Settings for the tube calibration

Review of Scans from Indian Point

Figure 1 Profile of the defect in tube R2 C69 of steam generator 24 as measured with the high-frequency plus-point at 1000 kHz and 800 kHz.

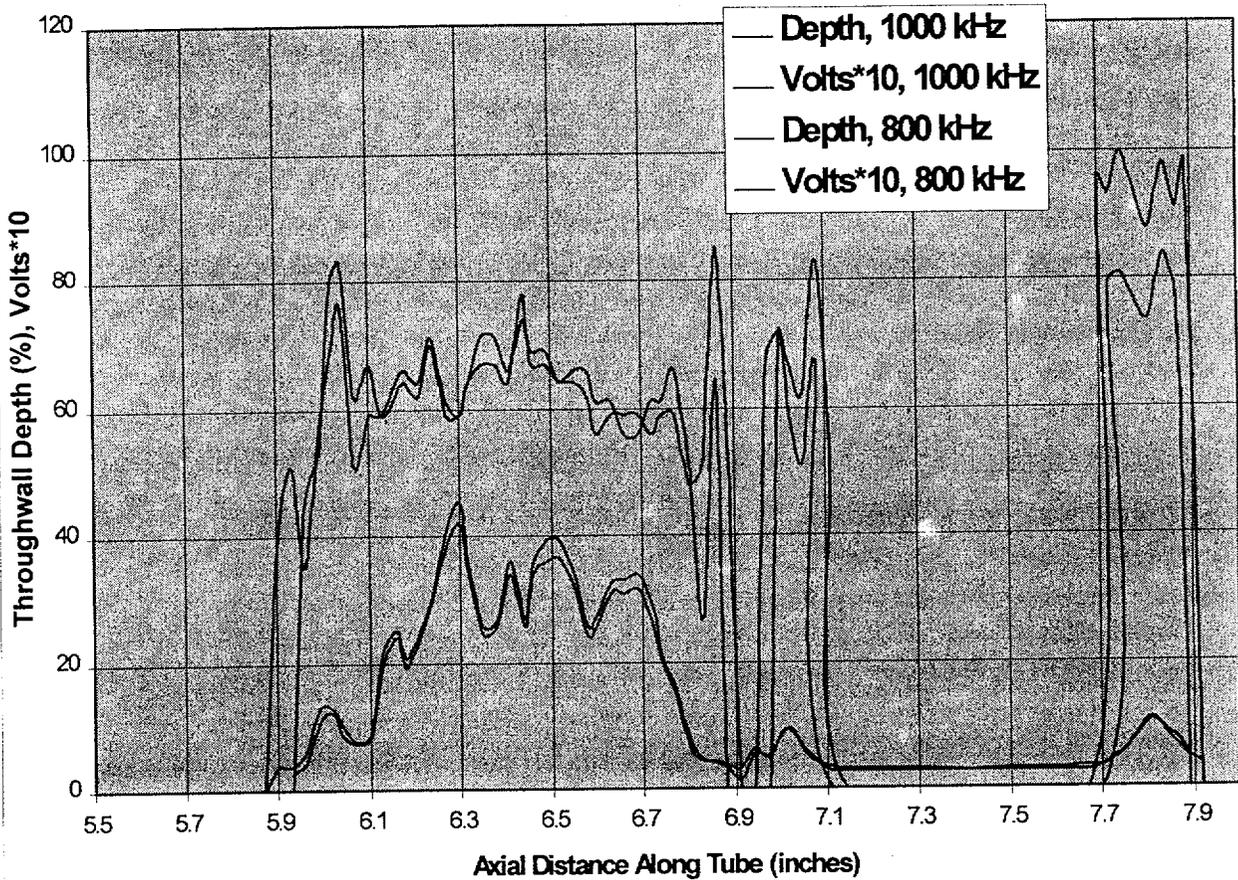
ured at the two frequencies is about the same. However, this tube had very little noise even with the old mid-range plus-point probe. The indication located at about 7.8-inches has a maximum value slightly greater than a volt, and the agreement between the two frequencies is not as good in this region. This defect at 7.8-inches was not included in the profile mid-frequency plus-point results furnished by the utility.

For indications on the tube id, the voltage increases as frequency increases. The opposite effect is observed for indications on the tube od. Also, for od indications, the phase rotates clockwise as the frequency decreases. For id defects, with the calibration used above, the phase stays constant with frequency. This tube leaked at 5173 psig in the utility test.

Figure 2 Profile of the defect in tube R2C71 in steam generator 24 as measured with the high-frequency plus-point at 1000 kHz and 800 kHz.

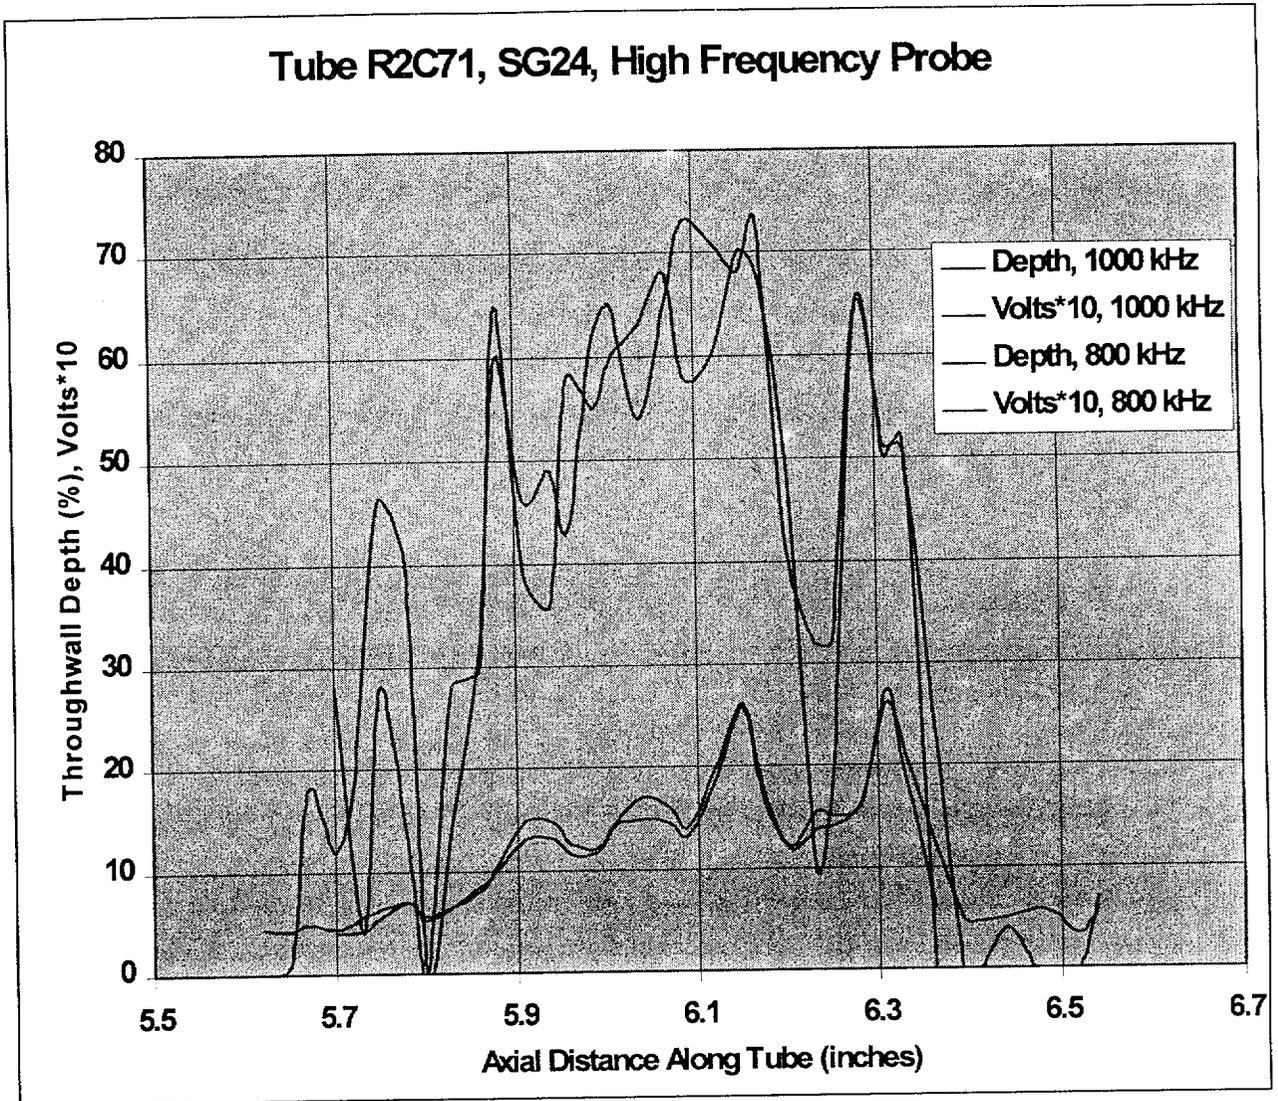
In Figure 2 we show the profile of tube R2C71 of steam generator 24. This tube had a small leakage at 2841 psig. The pressure could not be increased past 4500 psig due to the lack of capacity of the pump. Note that this tube was missed in the earlier inspection with the mid-range probe. The depth profiles at 1000 kHz and 800 kHz do not match each other as well, which is

due mostly to the low voltages that are present. This tube has about the same depth measurements as tube R2C69 in Figure 1, but the voltage values are only about half as large. Note the depth measurements do not agree well where

the magnitude of the voltage is low. When the voltage falls below 0.5 volts, the depth measurement becomes quite inaccurate.

Figure 3 Profile of the defect in tube R2 C74 of steam generator 24 as measured with the high-frequency plus-point probe at 1000 kHz and 800 kHz.

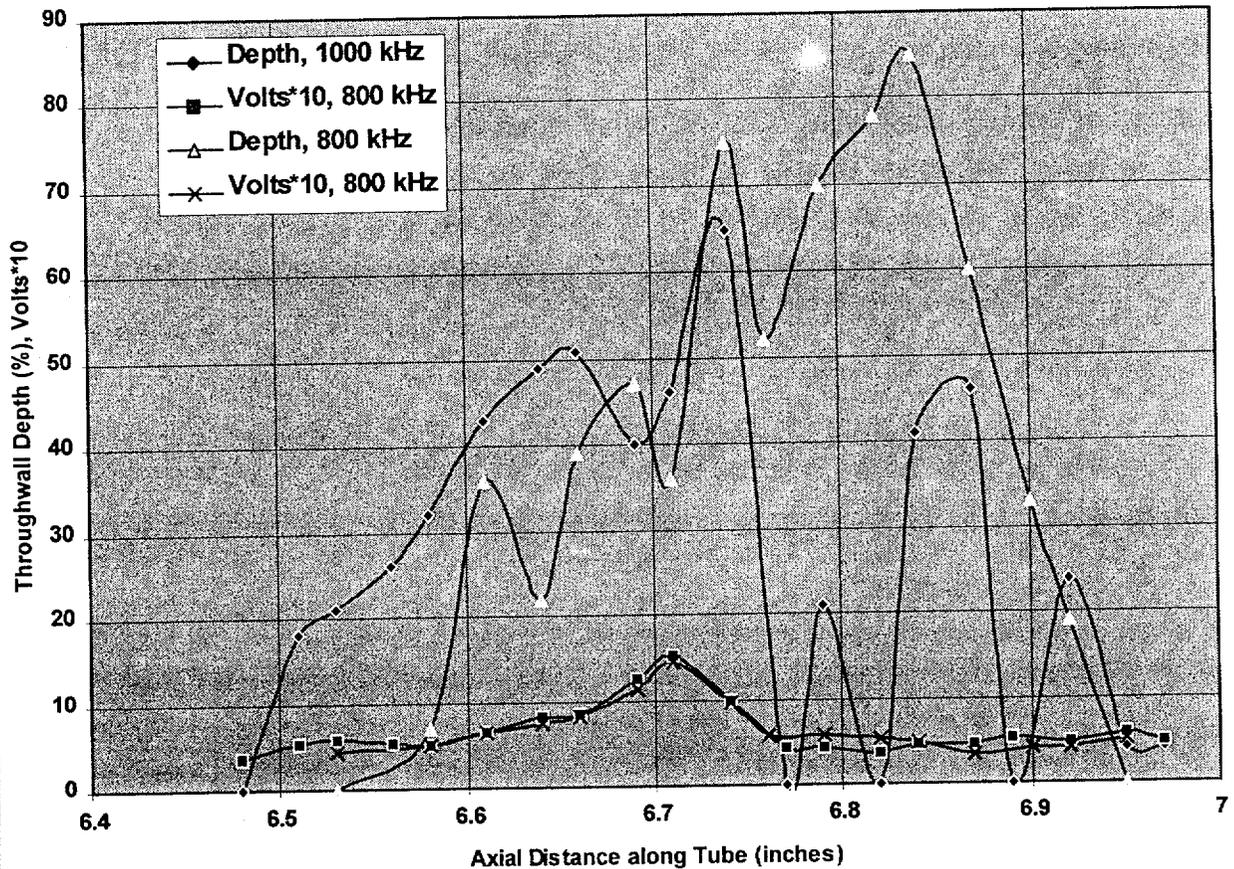
The profile plot for tube 2-74 is shown in Figure 3. The defect

has a maximum voltage of only about 1.5 volts. There is very poor agreement in the depth measurement at the edges of the defect where the voltage is small. There was some noise that increased as frequency decreased at the 6.8 to 6.9-inch region of the tube. This tube has a portion of the defect that measures in the 40% to 50% deep range, between 6.6 and 6.7-inches. This shows some of the probe's ability to measure and detect defects in this depth range. Unfortunately, this tube leaked at 5500 psig.

Figure 4 Profile of the defect in tube R2 C4 of steam generator 24 as measured with the high-frequency plus-point at 1000 kHz, 800 kHz and 300 kHz.

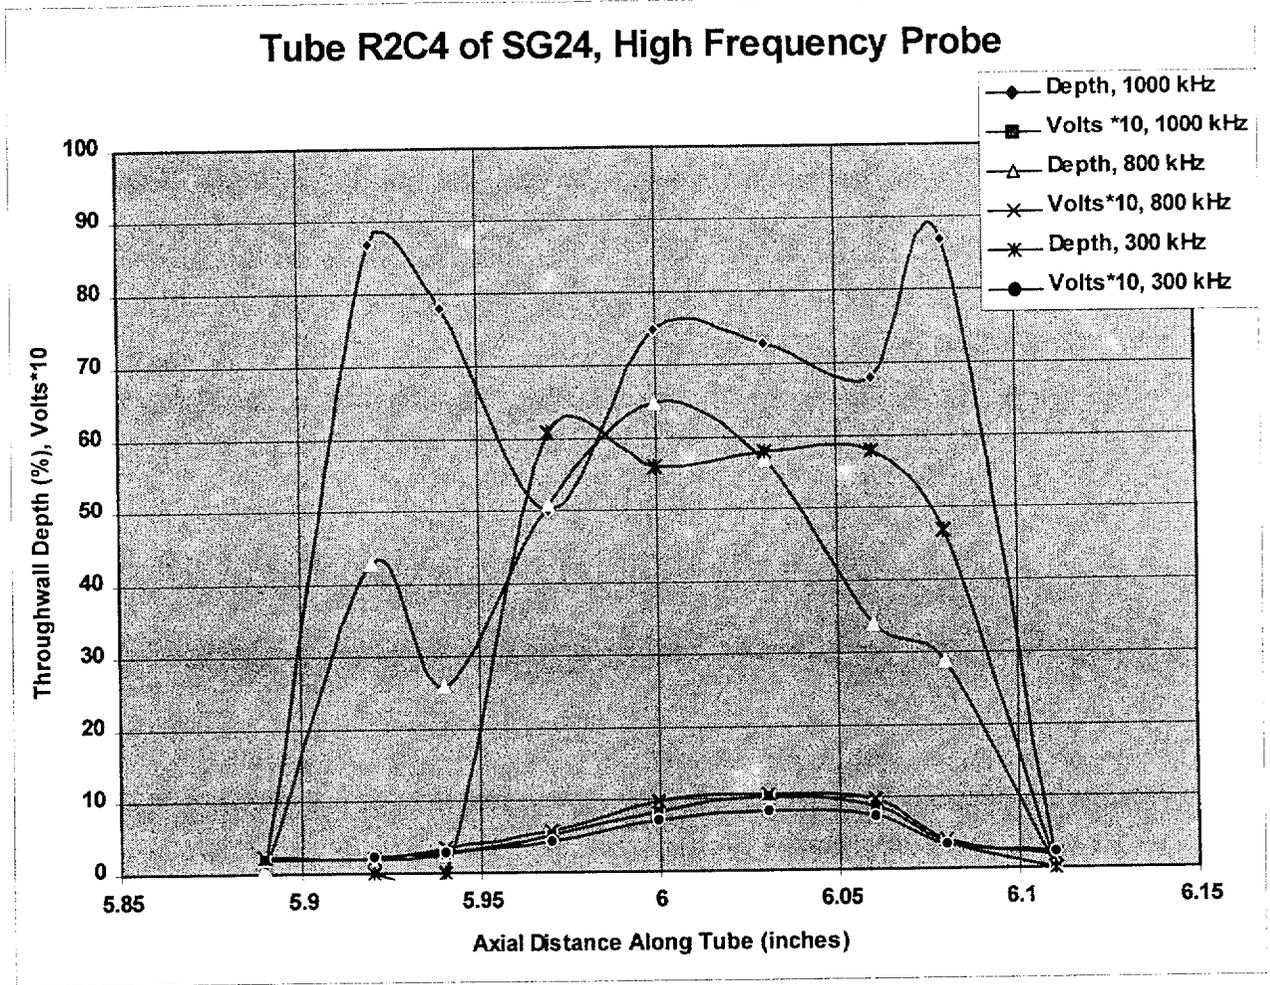
In Figure 4 we show the profile of tube R2 C4 of steam generator 24. This tube was profiled with the high-frequency

at 1000 kHz, 800 kHz and 300 kHz. The maximum voltage measured for this tube was only slightly greater than a volt, which probably has caused the wide variation in depth measurements at the different frequency. This defect is the shortest of all of the defects that we have looked at thus far. This tube did not leak at 5500 psig.

Figure 5 Profile of the defect in tube R2 C72 of steam generator 24 as measured with the high frequency plus-point at 1000 kHz and 800 kHz.

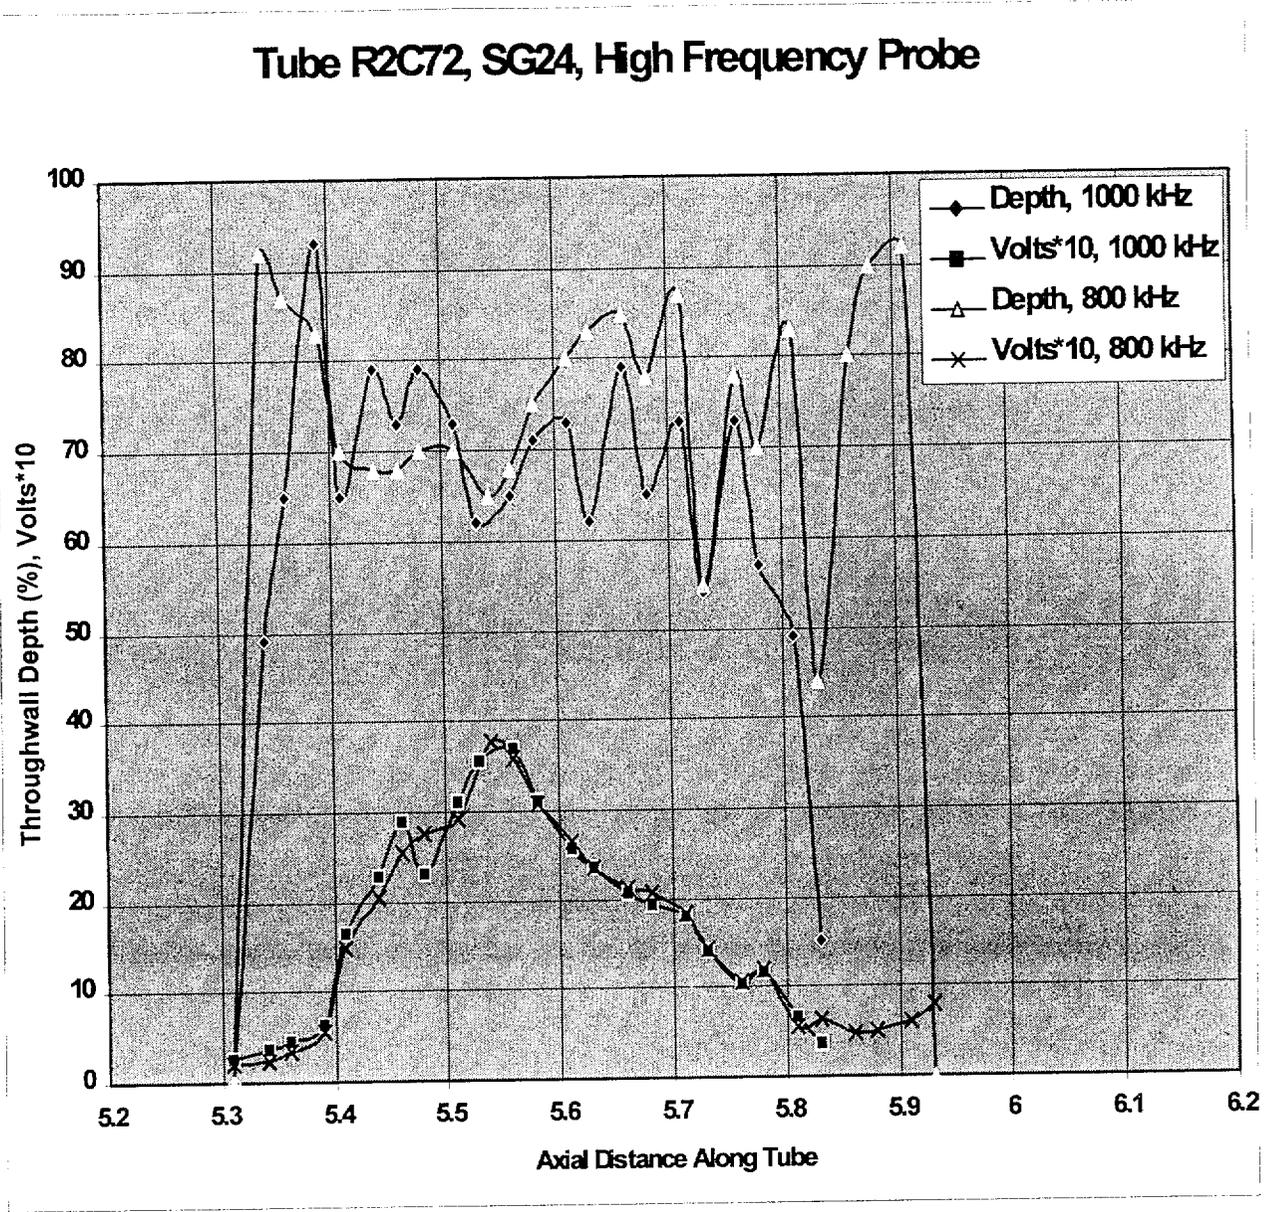
In Figure 5 we show the profile of tube R2 C72 in steam generator 24. This tube has a relatively

age and the phase measurements show a deep depth. However, this tube did not leak at the 5500 psig pressure test, although tubes with more shallow defect measurements and lower voltages did leak. As with the previous tubes, the depth measurements made at higher-voltage agree but not for the lower voltage measurements. There appeared to be od deposits that were influencing the signal at the 5.8 to 5.9-inch location.
